Objection to Development Application DA2019/1154

Alterations and additions to an existing dual occupancy (Submitted: 21/10/2019)

1 / 12 George Street MANLY NSW 2095

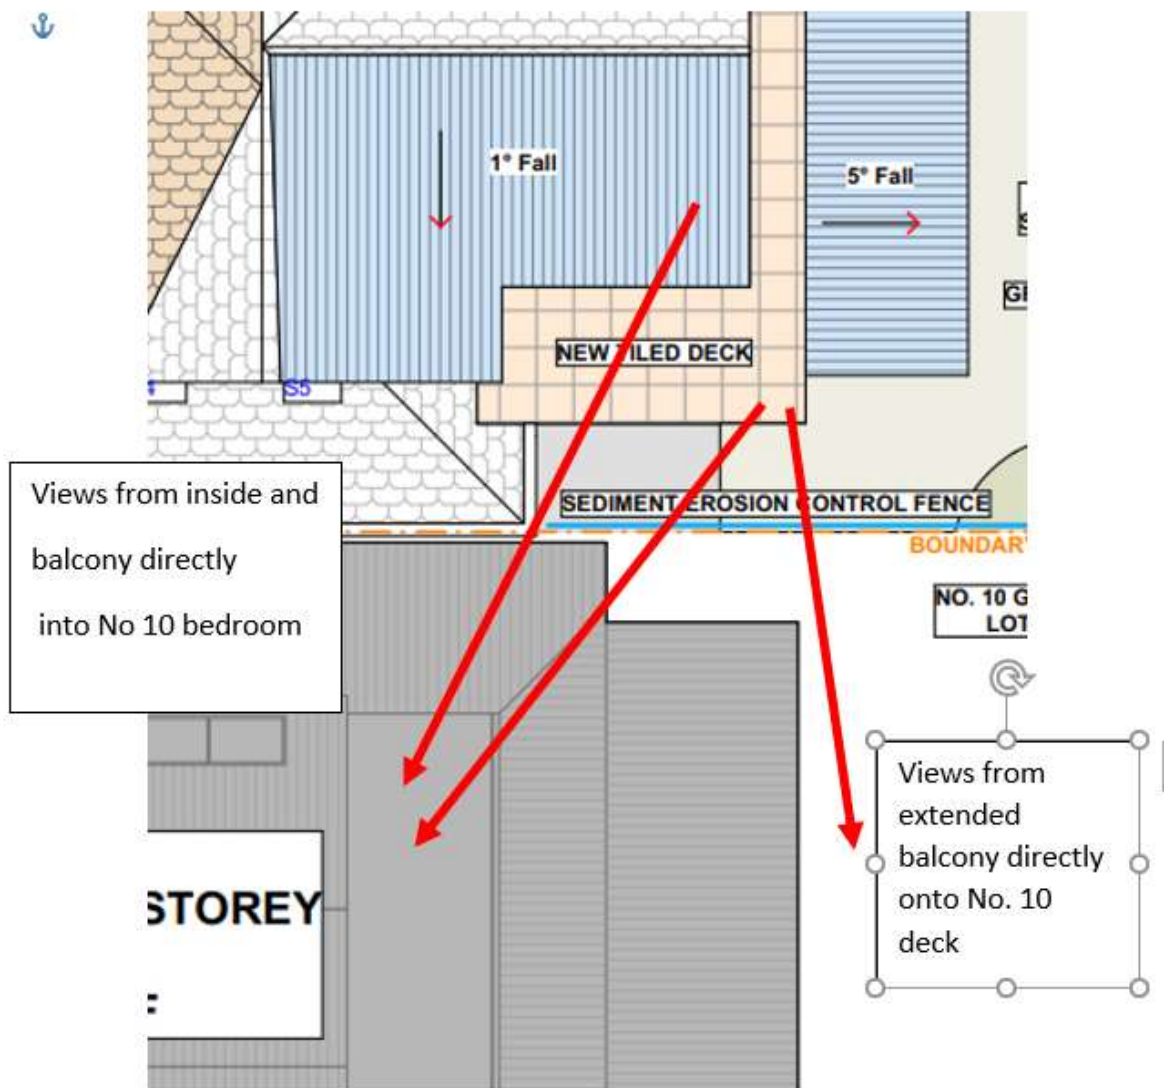
1. The extended balcony, new windows and doors which face no. 10 pose a significant impact to privacy. You will be able to look directly back into the bedroom and bathroom of our property from many angles. I have demonstrated this in the first diagram below.

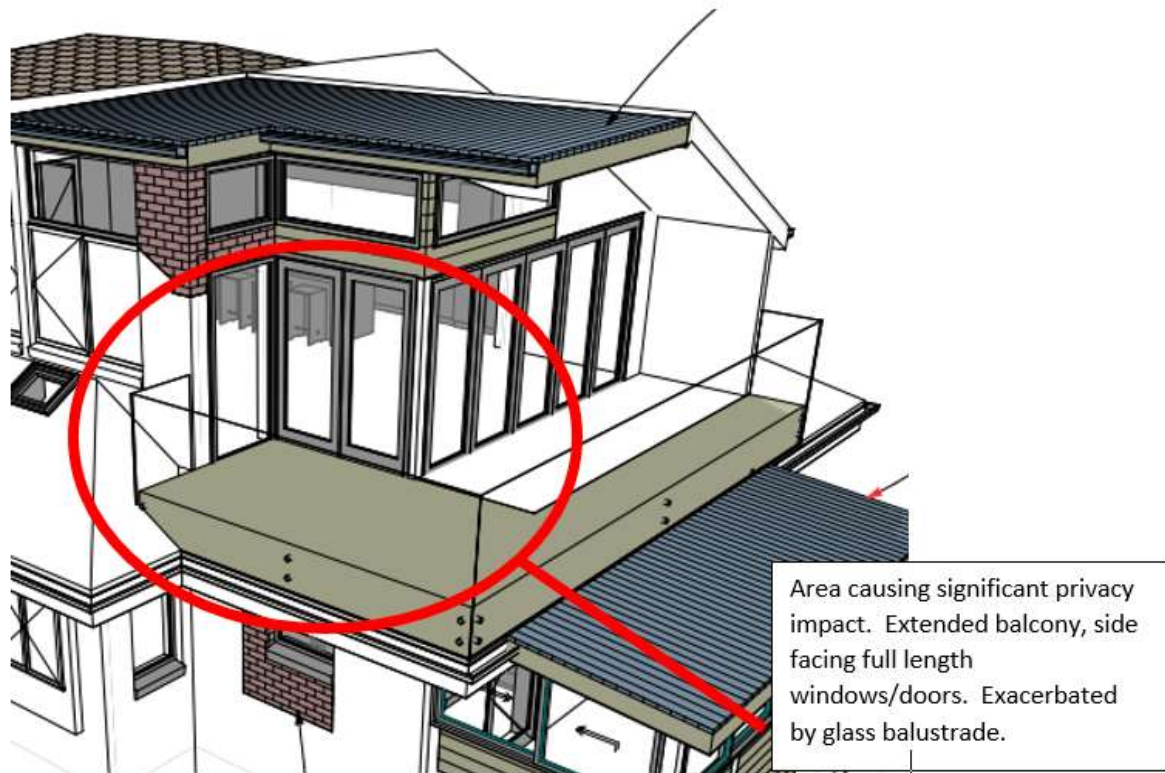
2. In consultation with council I was actively discouraged from any new side facing windows. The only one we have had approved had to be altered and covered in a privacy screen. I don't believe the part of the design I have highlighted in the second diagram considers privacy. Full length side facing windows/doors will provide views all the way into each other's property. This is exacerbated by the glass balustrades. We were also required to stay within the hip of our roof in our upper balcony.
